## Product Change Notice

Carrier tape pocket design change

Existing	New

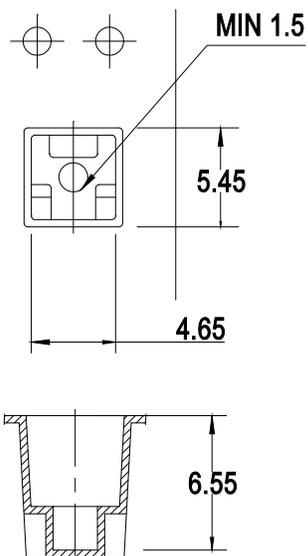
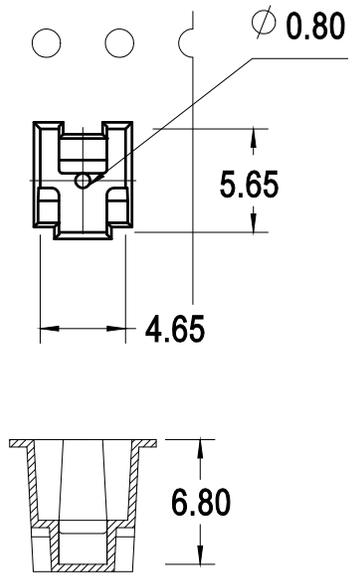
The carrier tape design will be modified for better LED fitting. The table below shows the comparison of the existing and new carrier tape design.

Improvement on the design of the carrier tape, which will allow a firmer positioning of unit inside the pocket.

The change is limited to the carrier tape design only. There is no change in the material of the carrier tape. There is no change in the fit, form and function of the device.
